SERVICE BULLETIN: JSB031

Issue: 3

Subject: Engine Through Bolt Replacement and Upgrade

Affected Models: Jabiru 2200 & 3300 Engines in FLIGHT TRAINING

Figure 1 – General Engine Layout

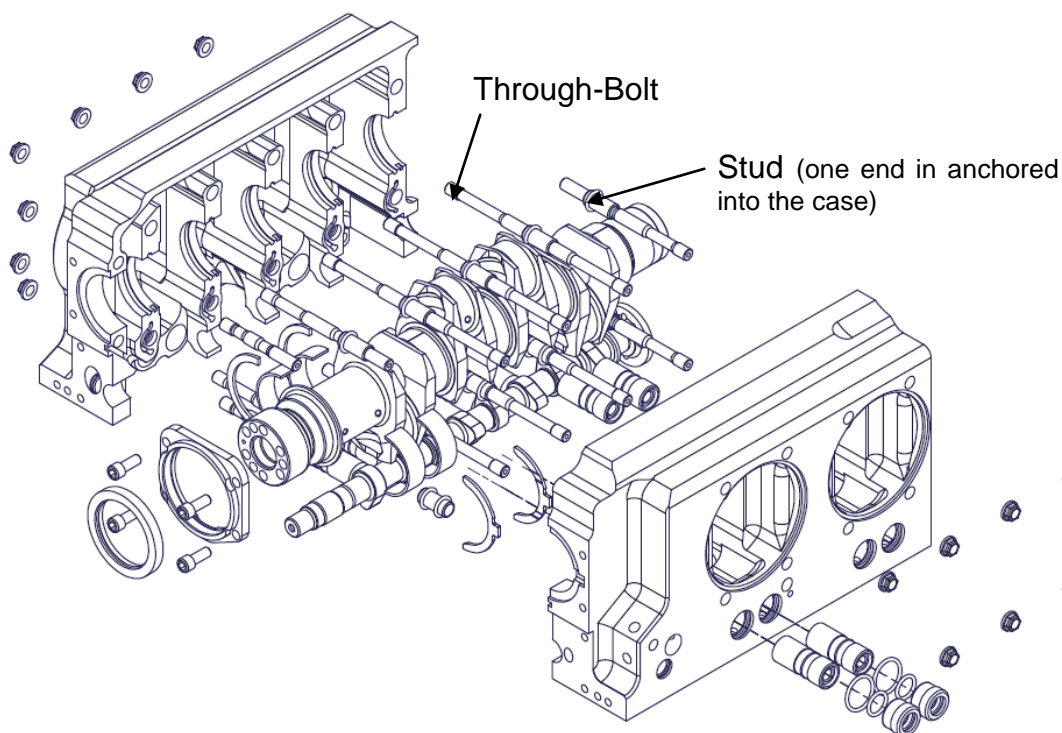
- Jabiru Engines are assembled using a combination of Through-Bolts and Studs – as shown in Figure 1 below. The number of through-bolts varies depending on which engine model is considered but there are always 6 studs (not all with the same part number). The through-bolts and studs hold the cylinders in place and the halves of the crankcases together.

Figure 2: Bolt torques.

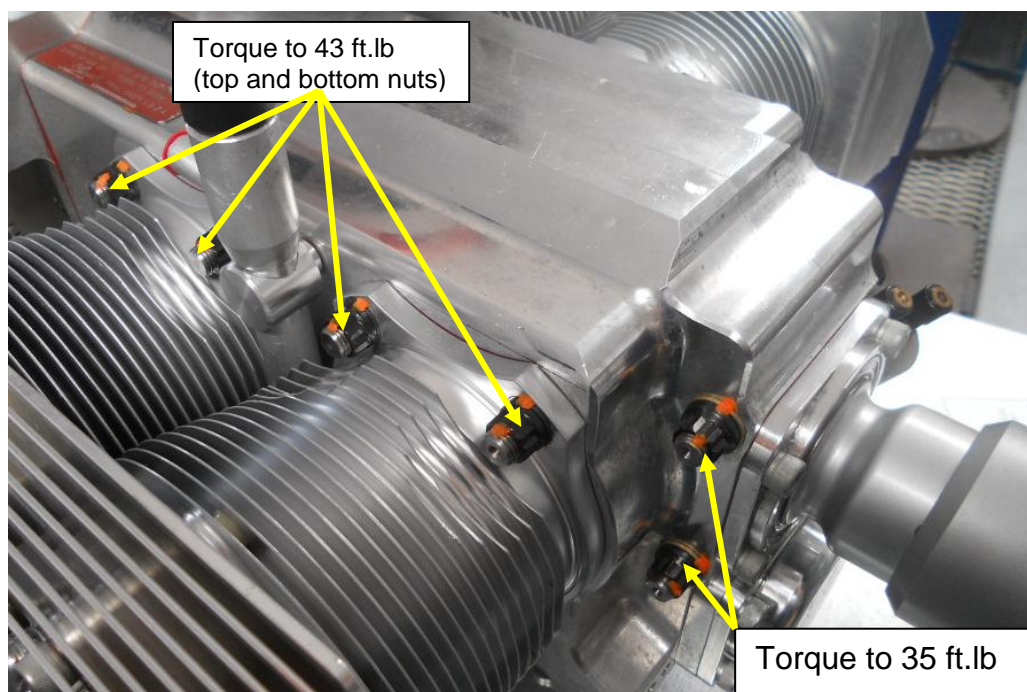
At the next 25hrly service, check the torque setting of 12 point nuts with a calibrated torque wrench. Prior to checking the torque, conduct crankshaft friction test as per section 6.2. If the torque was found to be less than 43 ft/lbs they should be retorqued to 43 ft lbs, if they are less than 43 ft lb. Reapply torque seal. Please see Figure 2.

Only loosen and change the nuts/washers on one bolt at a time. Then torque to 43 ft lb before undoing the next bolt. This will avoid losing too much clamping force of the case. If a locking compound was used on the bolt/nuts, threads must be cleaned before nuts are refitted. Once all bolts are done check the torques and apply torque seal. Please see Figure 2.

- The latest through bolt configuration of 7/16" through bolts and studs, 12 point ARP nuts and hardened steel washers all installed **without thread locker (Loctite)** to a torque setting of 43ft.lb (35ft.lb for the front two short studs) has been developed to increase the life of the through bolts of engines used in flight training.

- 3/8" bolts **should not** be torqued to 43 ft.lb, they are currently torqued to 35 ft.lb. Don't be tempted, this will generate excessive bolt tension!

Figure 3: Coil position.

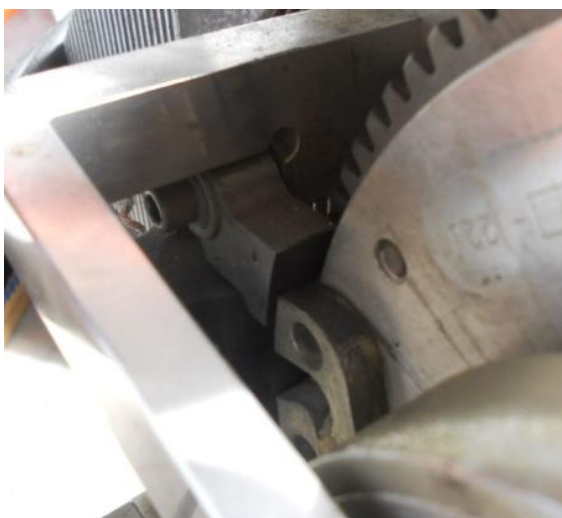
- Perform a crankshaft friction test before through bolt engine work commences. This can be done by measuring the force required to turn the propeller with a spring scale. Remove one spark plug from each cylinder. Turn the engine over several times. Position the crankshaft so that the magnets are almost lined up with the ignition coils, see Figure 3. Then using a spring balance at the tip of the propeller blade, (take care not to damage the propeller blade) pull the prop slowly in the direction of rotation. Take note of the reading on the scale as you do this. You will only get about 150mm of movement before the camshaft causes the prop to move more easily.
